SUBJECT: CATAWBA NUCLEAR STATION, UNIT 2 RE: ISSUANCE OF AMENDMENT
(TAC NO. MB1498)

SAFETY EVALUATION BY THE OFFICE OF NUCLEAR REACTOR REGULATION
RELATED TO AMENDMENT NO. 186 TO FACILITY OPERATING LICENSE NPF-52

CATAWBA NUCLEAR STATION, UNIT 2

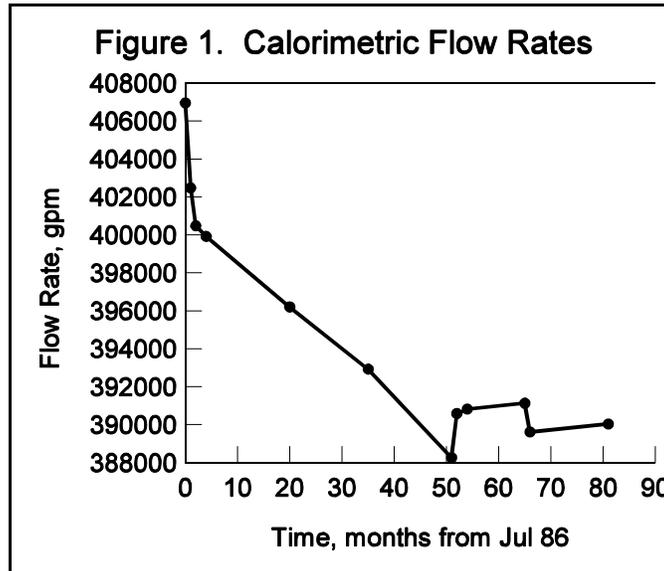
The calorimetric-determined flow rate values from Table 1 are plotted in Figure 1. The licensee excluded the July 1986 value because it was based on data obtained at 75 percent power (Reference 6), in contrast to the remaining values based on 98 percent or greater power. It used the remaining 11 values to establish its approved elbow coefficients. It proposes using the September and November 1986, and March 1988 values to establish elbow coefficients. The licensee believes the September 1986 and November 1986 values have less thermal streaming in contrast to the March 1988 value, which the licensee states “contains a

significant amount of hot leg streaming penalty[.]” Reference 3). The licensee identified RTD bypass removal prior to Cycle 2 restart in March 1988 as a candidate for some of the apparent streaming associated with the March 1988 and later calorimetric values (Reference 6). The licensee also stated that Cycles 1 and 2 “had a much flatter radial power distribution than the later low-leakage loading patterns ... so hot leg streaming was not as significant.”

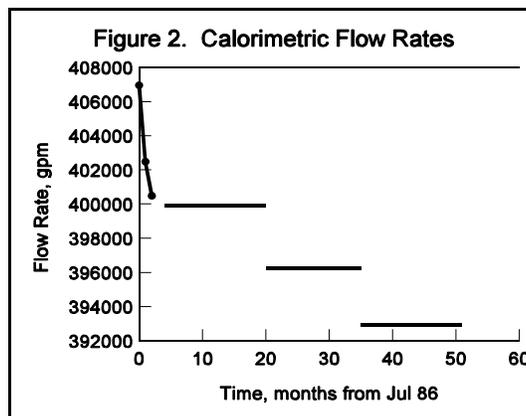
To assess these statements and their implications, we first assume the initial flow rate degradation is due to RCP impeller smoothing, as discussed in Section 3.2, below. Then we assume the later degradations are essentially due to physical changes during refueling outages and flow rate is essentially unchanged between outages. (This assumption is consistent with observed behavior.) This results in the Figure 2 representation of the early values.

licensee's model predicts this has little effect on RCS flow rate, which substantiates our judgement that SG tube plugging has little influence on flow rate during the first few months of operation. Since SG tube plugging does not significantly affect the flow behavior illustrated in Figure 2, we conclude that the apparent step flow rate decrease of 3700 gpm at 20 months is due to a combination of core reload and RTD bypass removal.

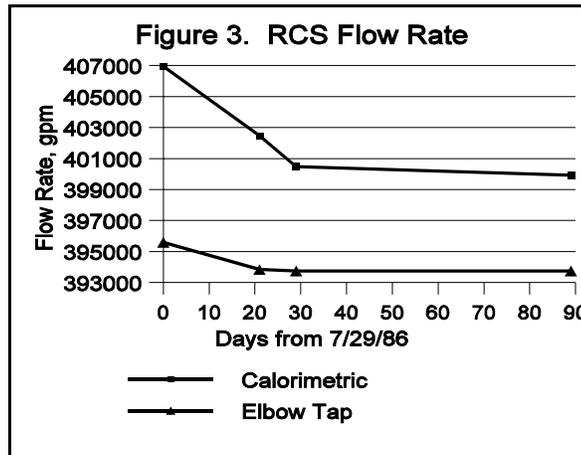
Consider the flow rate degradation illustrated in Figure 3, which provides the early calorimetric values and elbow predictions.³ The calorimetric values reflect the downward trend illustrated in Figure 1, but the elbow values are constant after the initial value. (We are interested in the trend in elbow values, not the values for purposes of this discussion since the elbow information results from coefficients obtained using 11 calorimetrics.) Neglecting potential error due to uncertainty in the values and a bias due to using 11 calorimetrics, the change in elbow value during the first 21 days of operation is about 1750 gpm, a change we believe is due to RCP impeller smoothing, as identified in Section 2, above. Further, the elbow information implies there was little smoothing after 21 days. Since some impeller smoothing will have occurred before the Figure 3 information was obtained, on this basis the total smoothing effect will be greater than 1750 gpm.

Although the first calorimetric was made at 75 percent power, we note the trend is consistent with the second and third values and there is little inconsistency between the calorimetric and elbow trends, although the magnitudes are different. If we assume the calorimetric values are correct, then the flow rate decreases by 6500 gpm during the first month and, consistent with the calorimetric, is relatively constant during the next few months.

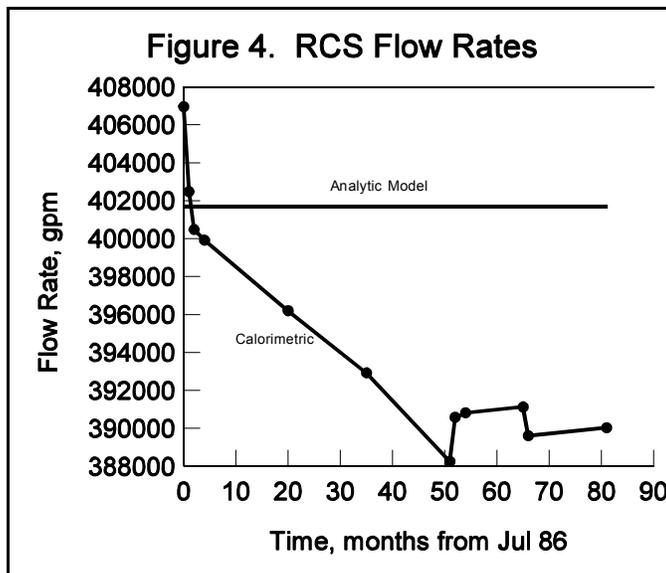
As illustrated in Figure 4 (References 2 and 5), the analytic model predicts an essentially constant RCS flow rate of ~401,700 gpm during the first few years of operation in contrast to the calorimetric determinations, which show significant variation.

There were 80 SG tubes plugged early in plant operation. The licensee's model predicts this has little effect on RCS flow rate, a reasonable prediction. However, the licensee did not address modeling changes associated with RTD bypass removal, and its model results do not reproduce the flow rate increase illustrated by the elbow response following manifold removal and as-expected from that removal. The licensee should ensure the model correctly represents these flow perturbations.
